Perpendicularity Refinement

Recently a client asked me to look at a drawing that is similar to the one shown in Fig. 6-4A below. This part has three coaxial cylinders. The smallest cylinder must be coaxial to the 2.000 diameter cylinder within a cylindrical tolerance of .010 in diameter, and both cylinders are to be perpendicular to datum feature A within a cylindrical tolerance of .005 in diameter.

Figure 6-4A The inappropriate use of the position control to control perpendicularity

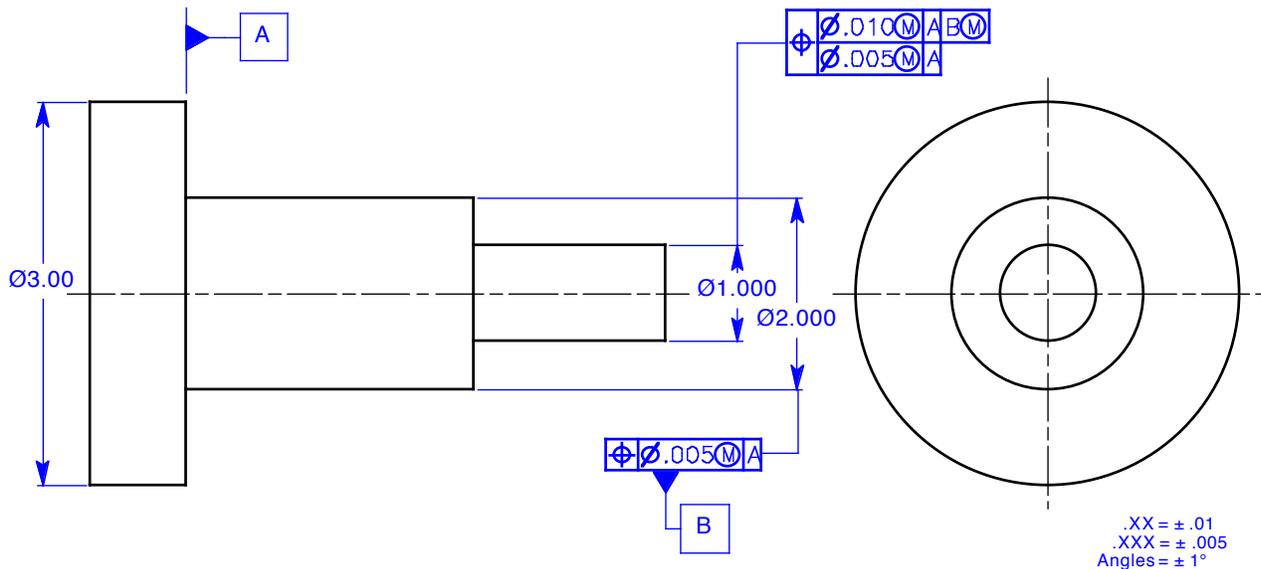
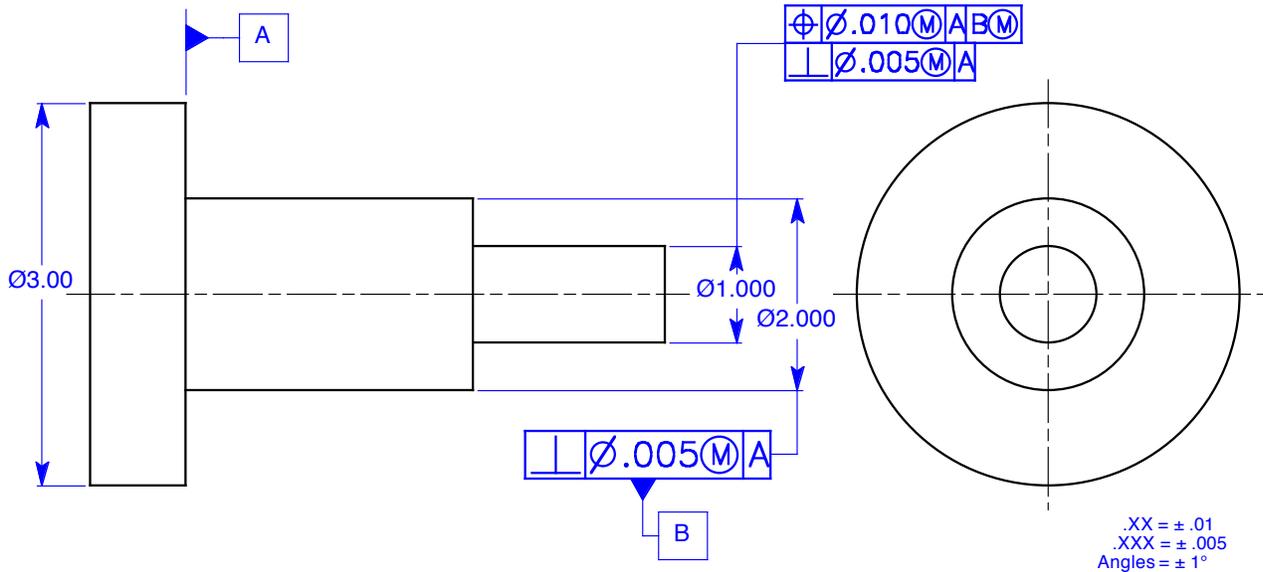
In an attempt to control the perpendicularity of the 2.000 diameter cylinder in Fig. 6-4A, the designer incorrectly tolerated it with a position control.¹ If perpendicularity is required, use the perpendicularity control. In other words, say what you mean. Although the tolerance of position does control orientation when it is used to locate a feature, it is not used solely to control perpendicularity. In this case, perpendicularity is the only relationship that must be refined. Consequently, the perpendicularity tolerance is the correct control for this application as shown in Fig. 6-4B below.

The composite tolerance shown in Fig. 6-4A is inappropriately applied to a single feature. This tolerance is only used to control patterns of features. A composite tolerance is used where the relationship from feature-to-feature in a pattern of features must be kept to a smaller tolerance than the relationship between the pattern and its datum features. Fig. 6-4B correctly shows the position control locating the axis of the 1.000 diameter cylinder within a cylindrical tolerance zone .010 in diameter, and a perpendicularity tolerance refining the orientation of the axis within a cylindrical tolerance zone of .005 in diameter. To refine the orientation of a single feature, specify the desired orientation tolerance, perpendicularity in this case, and place the orientation feature control frame beneath the location feature control frame.

There is one final problem with the drawing in Fig. 6-4A. The two and three-inch diameter cylinders have no coaxiality control between them. As a result, the drawing is incomplete. It is a common misconception that the size tolerance in the tolerance block will control the coaxiality between two individual cylinders. **The relationship between individual features is not** controlled by the limits of size. If features on a drawing are shown coaxial, or symmetrical to each other, and not toleranced for location, the drawing is incomplete. Fig. 6-4B has a note specifying the tolerance between coaxial features. The use of a note is one-way of specifying the coaxiality tolerance for two or more individual features. Some designers feel that specifying coaxiality on prints is “overkill.” As a result of their mistaken beliefs, their companies have either already purchased bad parts or will purchase bad parts in the future. The proper tolerancing of parts avoids confusion, saves time, and saves money.

Figure 6-4B The properly toleranced part shown in Fig. 6-4A
